RE: 140 Oakmont Way

I reviewed the previous drawings, evaluated the neighborhood context and prepared a review letter in January. My comments and recommendations on the revised design are as follows:

EXHIBIT 6

CURRENT DESIGN

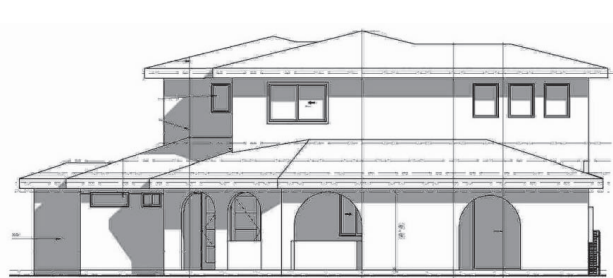
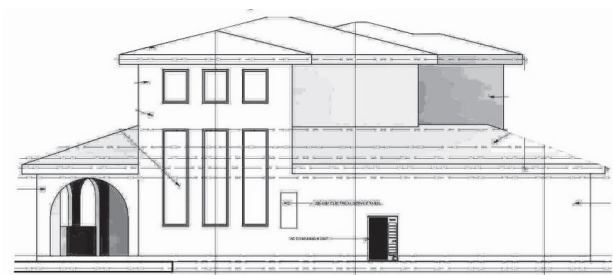
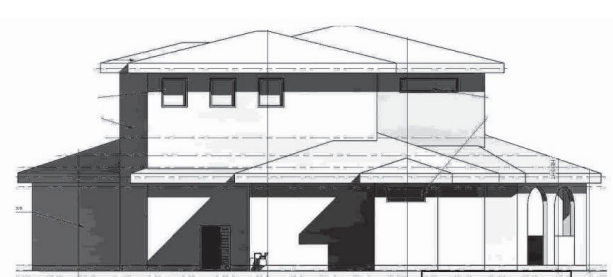
As noted the vast majority of nearby homes are one story in height. The proposed additions to this home would substantially increase its scale relative other homes in its immediate neighborhood and the extended neighborhood around it. The proposed front facade illustration and neighborhood photos below show the previous and current proposed design in comparison with nearby neighborhood homes.

In evaluating this proposed project in the context of the town's Residential Design Guidelines, it would be difficult to conclude that it fully meets the adopted design guidelines.

Several positive changes have been made in response to the previous review letter and recommendations but there are a few specific design conditions which are still not consistent with the Town's Residential Design Guidelines.

Building design refinements should focus on reducing the scale of the tall entry to blend better with the other homes in its immediate neighborhood, addressing other inconsistencies with the Residential Design Guidelines and refining the design details. I looked at a variety of refinements with the goal of maintaining the current floor plans and minimizing exterior form changes. Three possible refinements are shown on the following pages. They are basically the same with variations on the home entry.

1. Elimination of the two story tall entry form by changing the second floor covered balcony to an open uncovered space.
2. Simplification and unification of the window forms with the addition of detail in the form of true or simulated divided panes on all windows - see illustration below.

3. A deep recess of all windows frames from the outside face of the walls to be consistent with Residential Design Guideline 3.7.4.

4. Refinement and clarification of the eave details. They currently appear appropriate on the included front facade sketch but overly bulky on the elevation drawings.

The second floor covered balcony portion of the entry is replaced by an open balcony as is common in this architectural style. It would retain the essence of the applicant's proposed entry while reducing its visual height and bulk.

The second alternative would be similar to Alternative A by maintaining the basic design of the facade while extending the eave and roof over the entry in conformance with Residential Design Guideline 3.6.3. It would still provide an emphasis on the entry while simplifying its form to be more compatible with other homes in the immediate neighborhood.

This alternative provides an entry-under-the-eave as shown in Alternative B but retains the applicant's originally proposed arched entry opening.

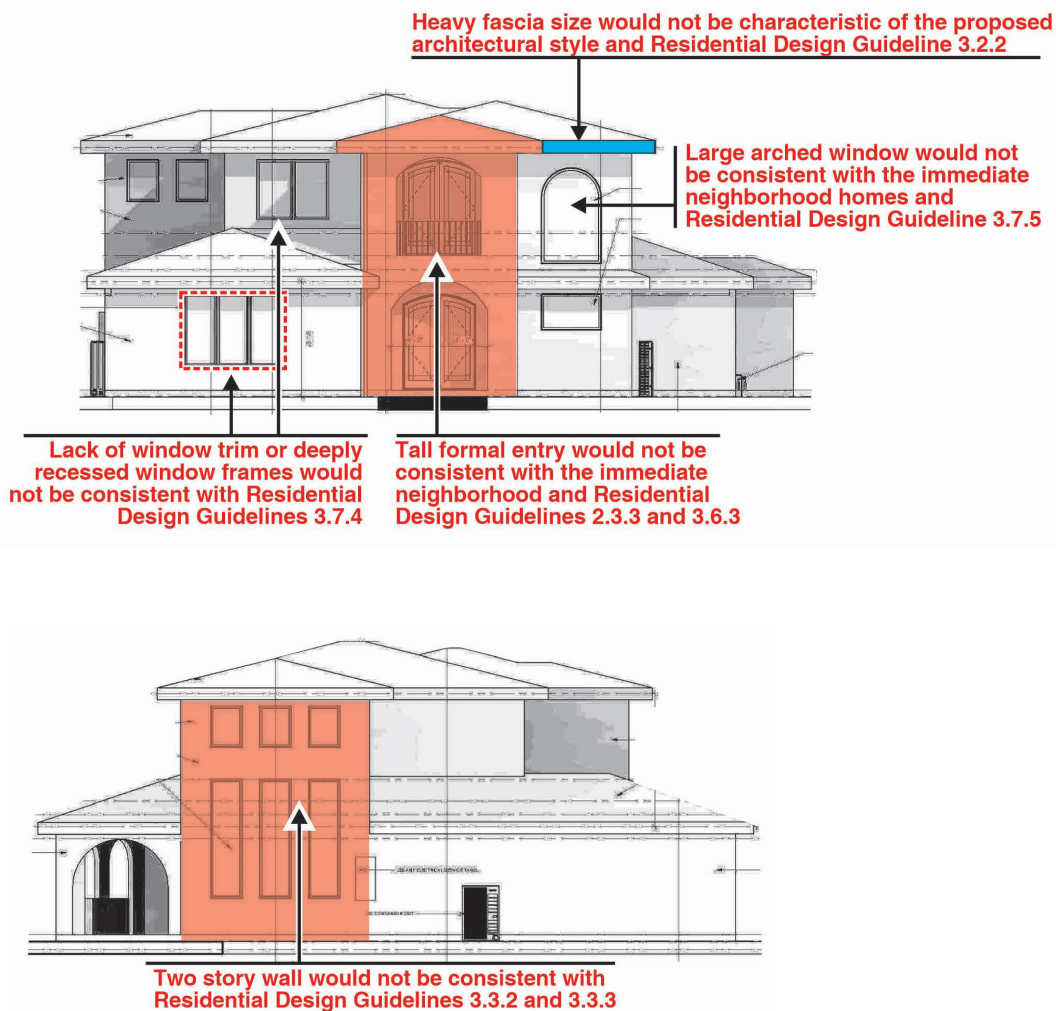
- *Avoid Estate Home Style windows (e.g., tall arched windows) in neighborhoods where the homes are more modest and informal in character.*
